# ATTACHMENT A

DATE: May 4, 2022

**TO:** Design Review Commission  
**FROM:** Jia Liu, Associate Planner  
**SUBJECT:** SC21-0046 – 628 Cuesta Drive

PROPOSED ELEVATION- EAST

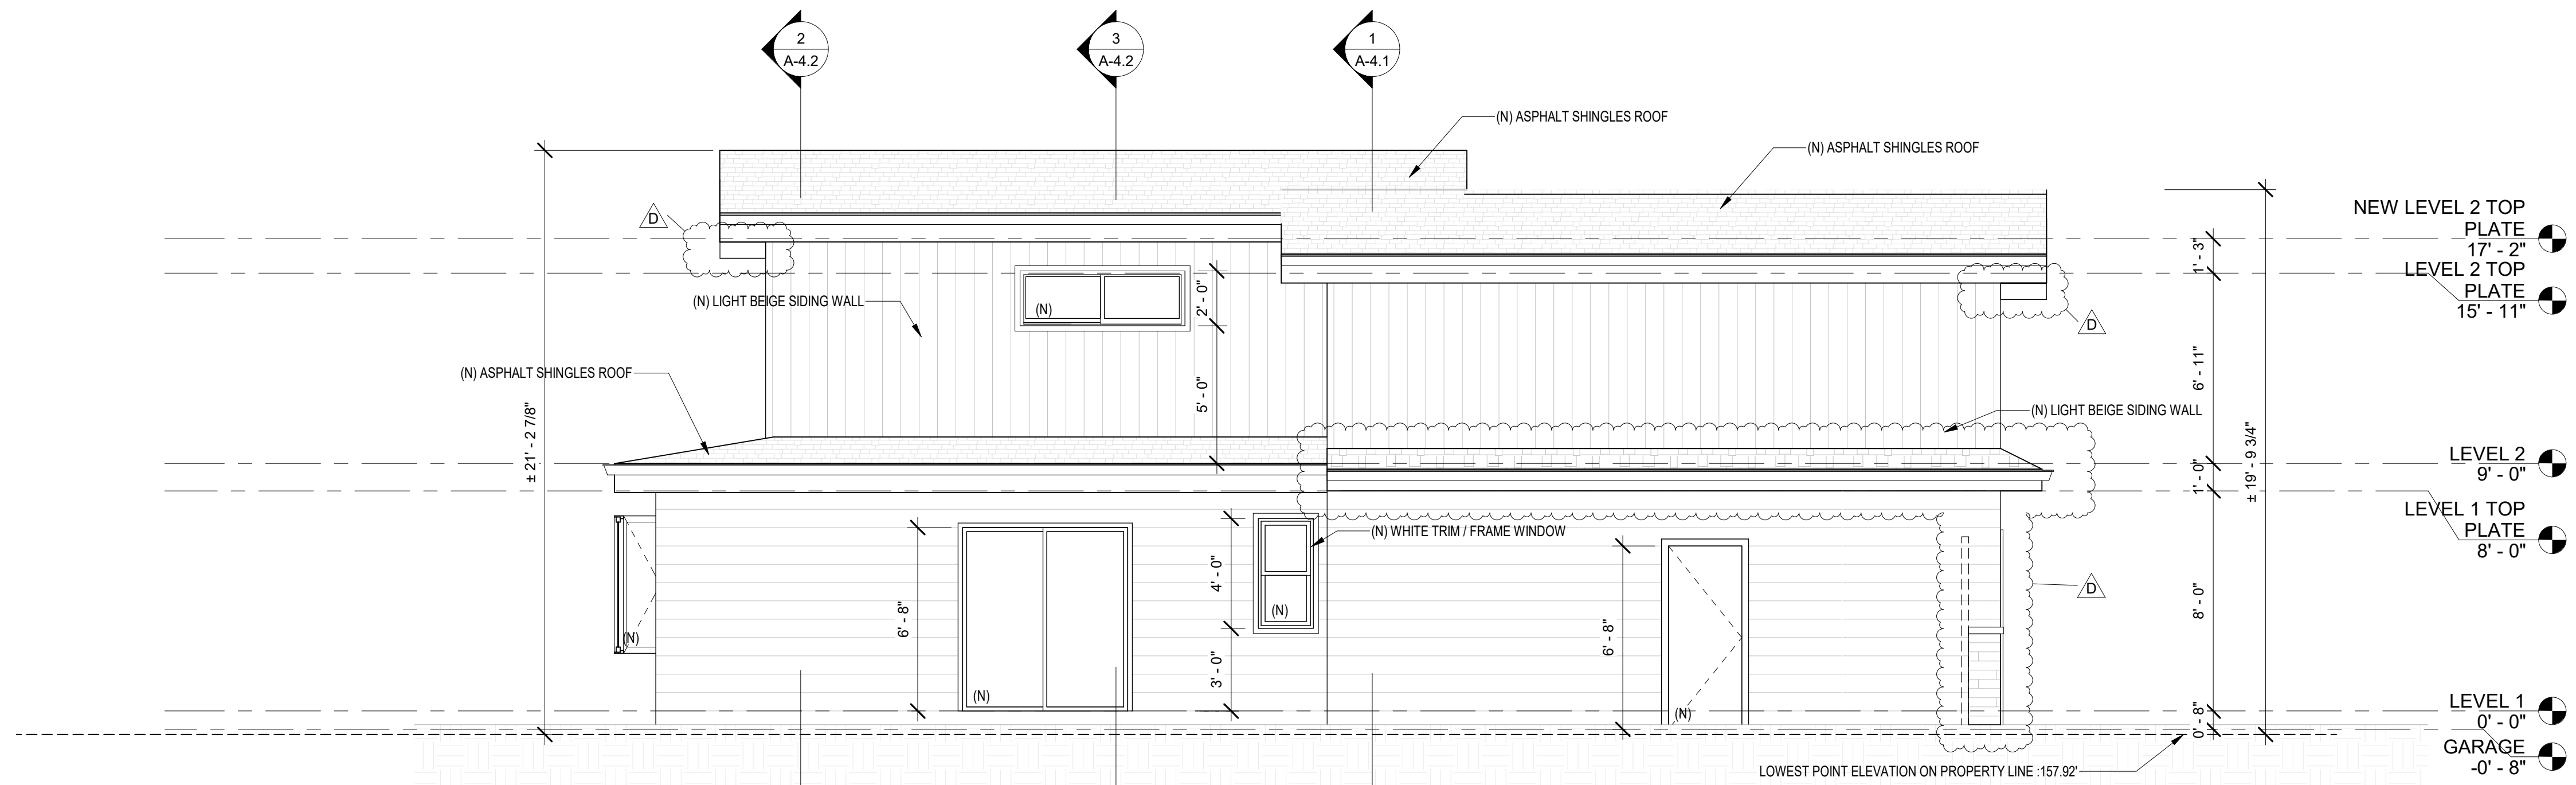
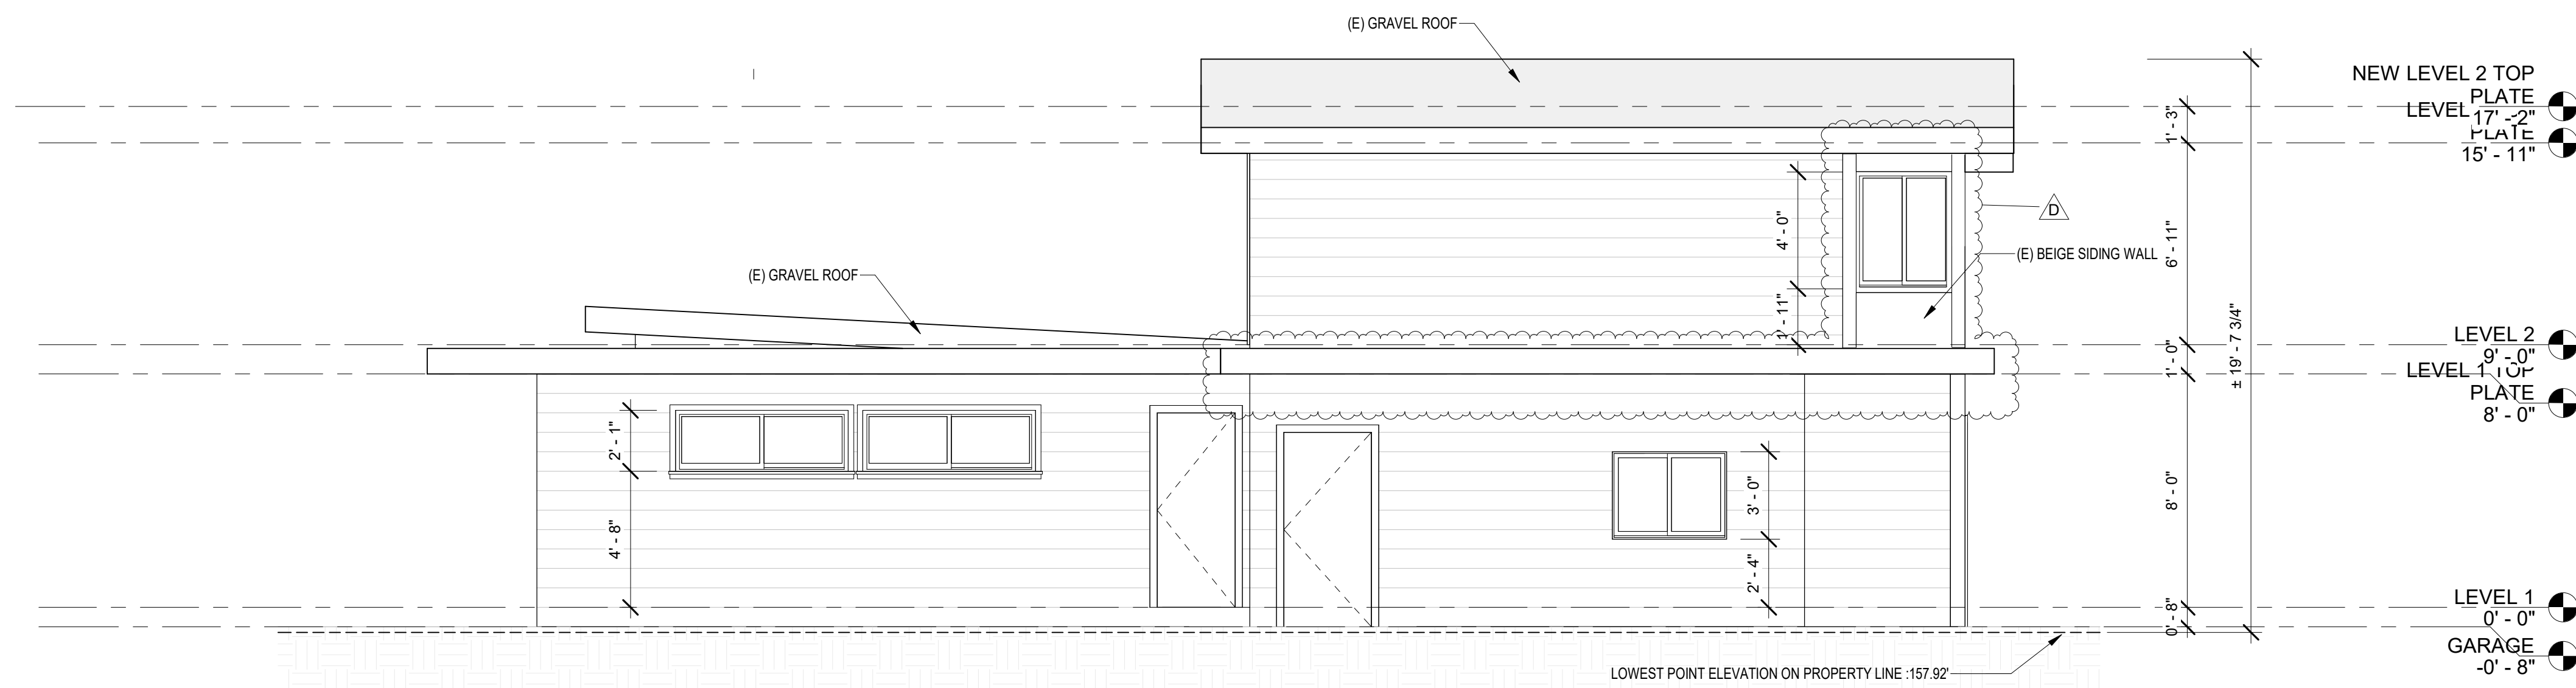
The proposed wainscoting with stone veneer at the exterior wall of the garage shall have the left (east)-side return along the left (east)-side elevation that end at least where the fence will be installed.
